PETITION FOR SITE PLAN AMENDMENT IN CASE NO. CR-82-69-A

TO: Members of ZP&C Date: July 15, 1983
FROM: Nicholas B. Mangione
Revised Site Plan - Reclassification Petition
SUBJECT: Item No. 9 - Cycle No. 1

PETITION AND SITE PLAN

BALTIMORE COUNTY ZONING PLANS ADVISORY COMMITTEE

Sheet Title
PLAT

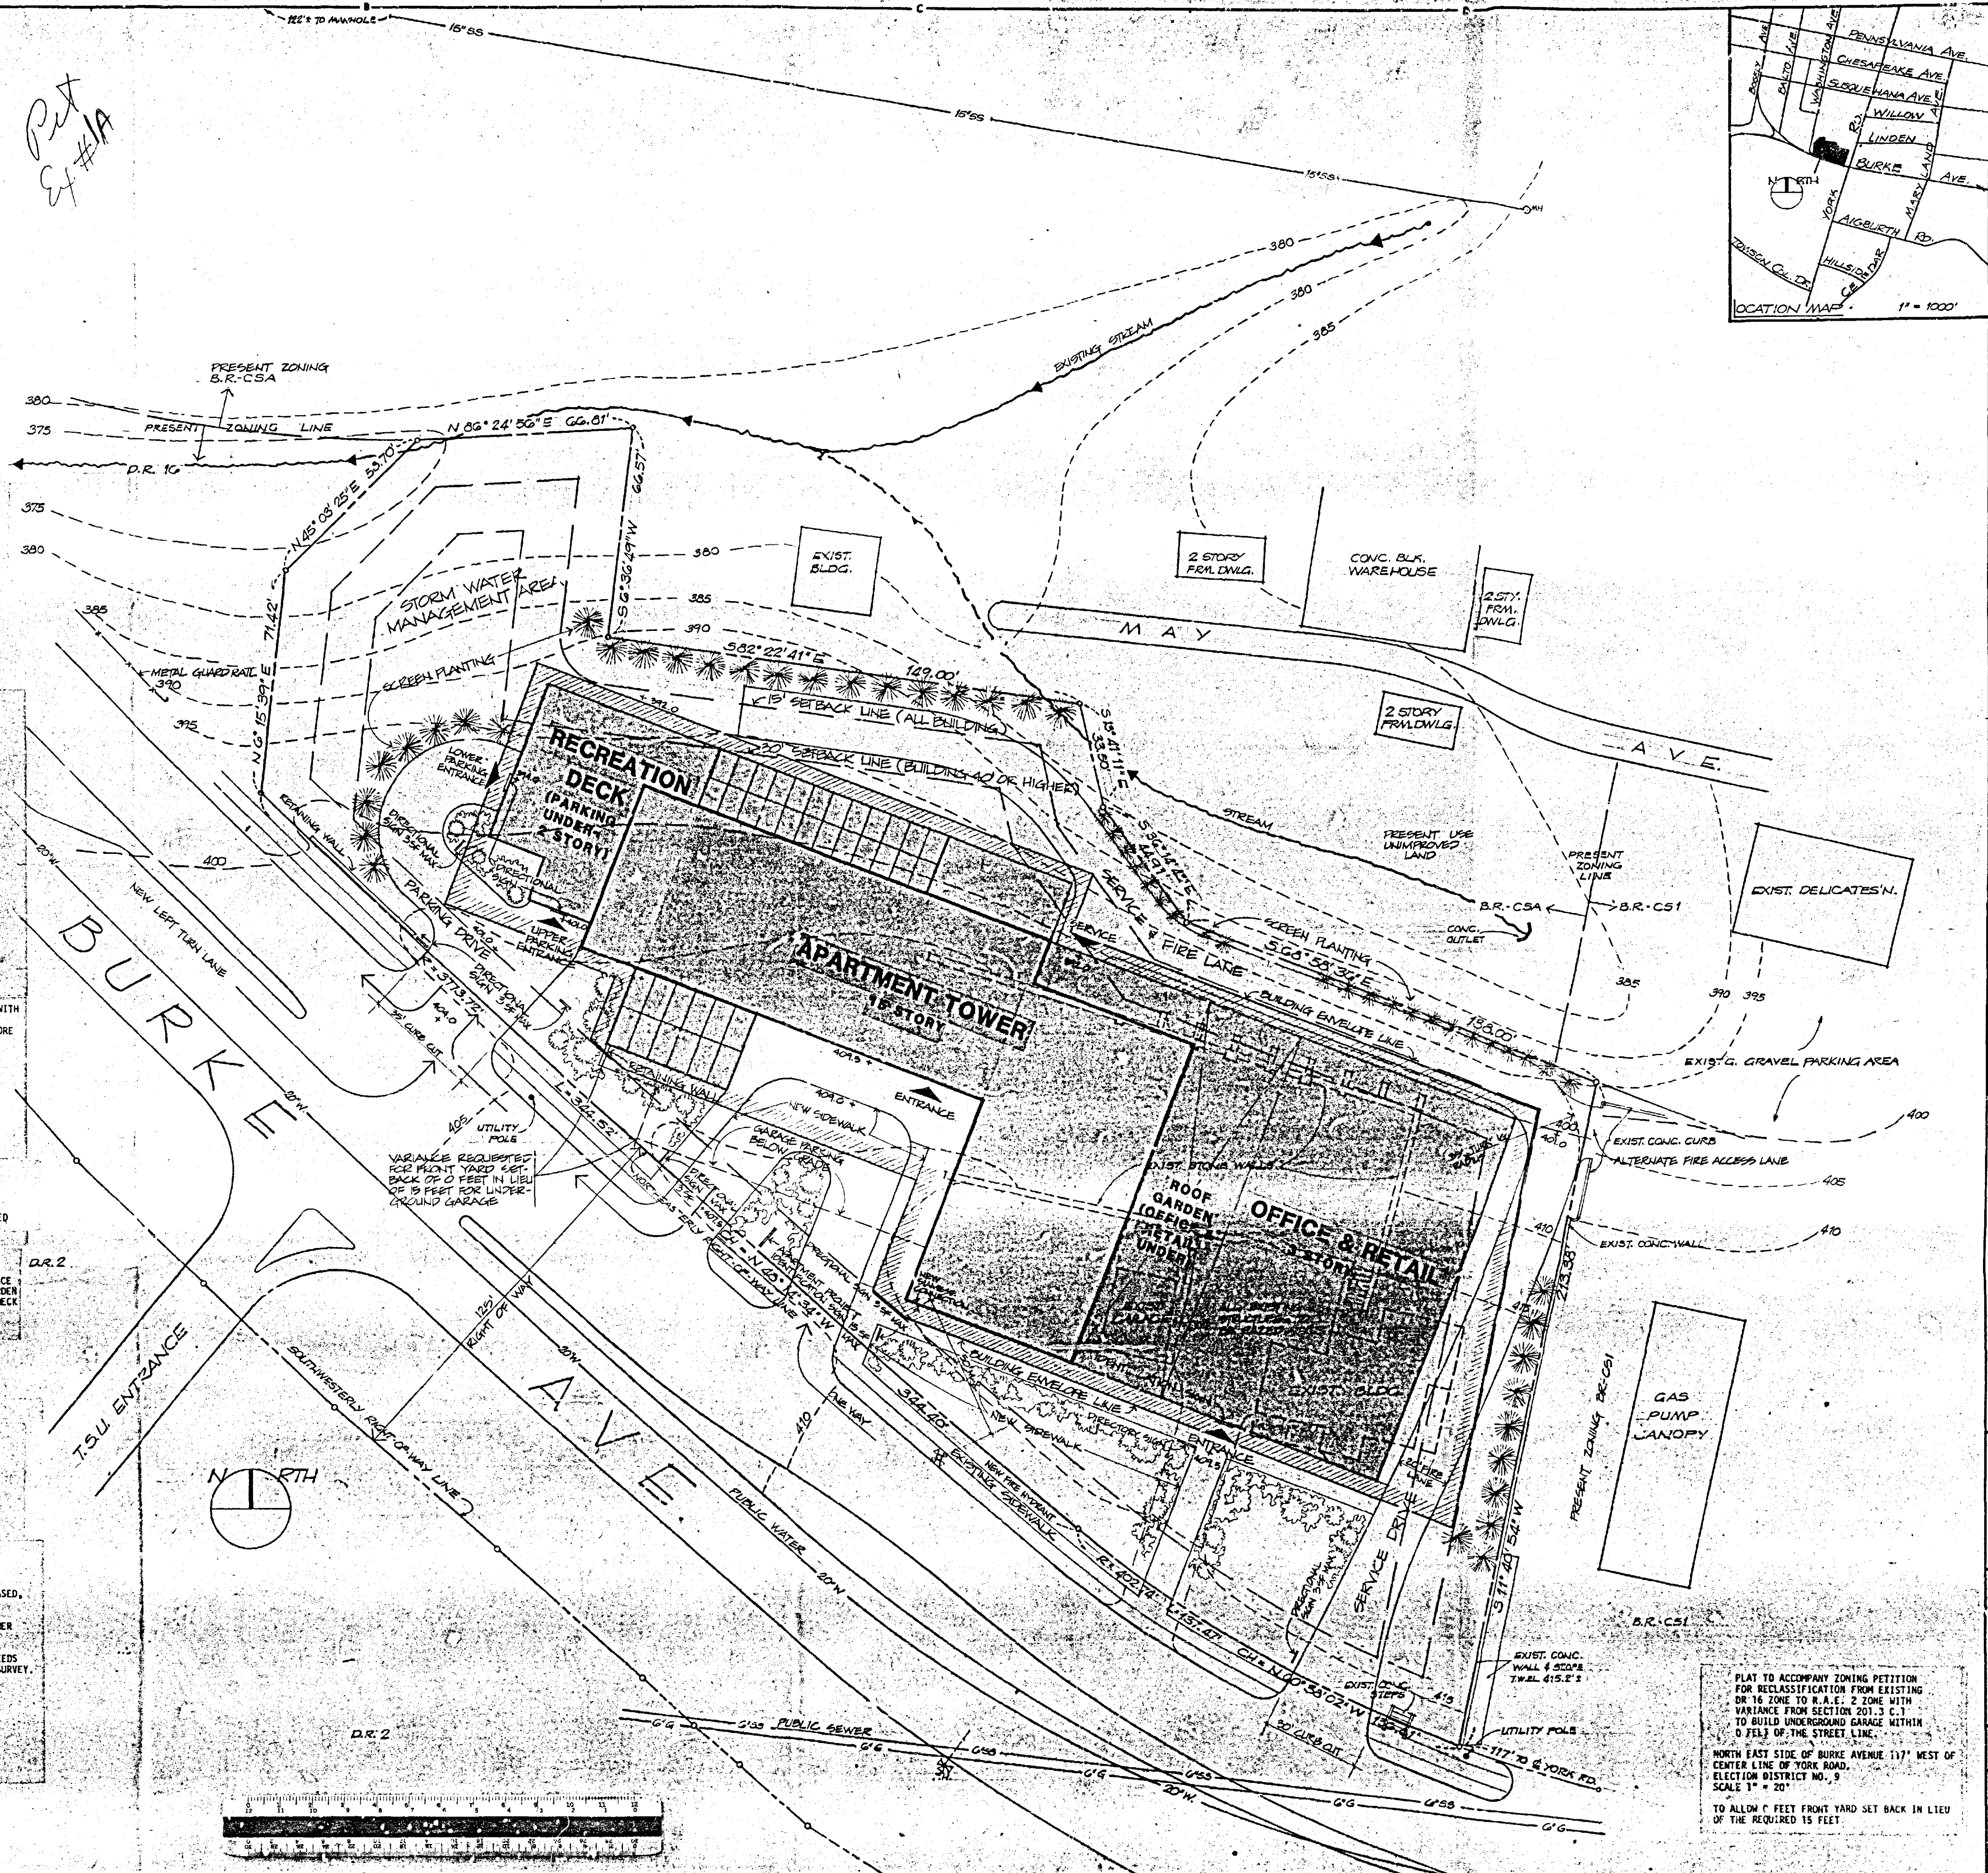
A 24-inch water main exists in West Burke Avenue and is available to serve this property. However, supplementary piping will be required to provide adequate water pressure to the upper floors of the proposed structure. Fire protection requirements, including additional public fire hydrants, will be determined by the fire department.

The subject plan does not indicate the method or means of connection to public sanitary sewerage. Public sanitary sewers exist in several locations beyond the limits of this property; however, it appears that an extension of the public sewerage system, along West Burke Avenue from the west, is required to serve this property. The existing sewer is part of the old Towson sewerage system and the most reliable information in regard to location and elevation is found in the Baltimore County Bureau of Engineering position sheets 21 and 37 NE 2 & 3. However, the Petitioner's engineer is responsible for determining, to his own satisfaction, the location and elevations of the existing sewer.

The subject plan does not indicate anticipated sewage flows, however, a sanitary sewer study will be required prior to approval of any grading or building permits to determine the adequacy of the existing sewerage system to accommodate sewage flows anticipated from the proposed development of this property. The proposed development of this site is also subject to the approval of the Maryland State Department of Health.

The site plan should be revised to show the entrance of the site aligned with the entrance of Towson State University.

No provisions for stormwater or drainage have been indicated on the subject plan; however, a drainage study and storm drainage facilities will be required prior to approval of any grading or building permit application for the proposed development of this property. The plat should be revised to indicate all existing and proposed drainage facilities and the location of Towns Creek in respect to this property.
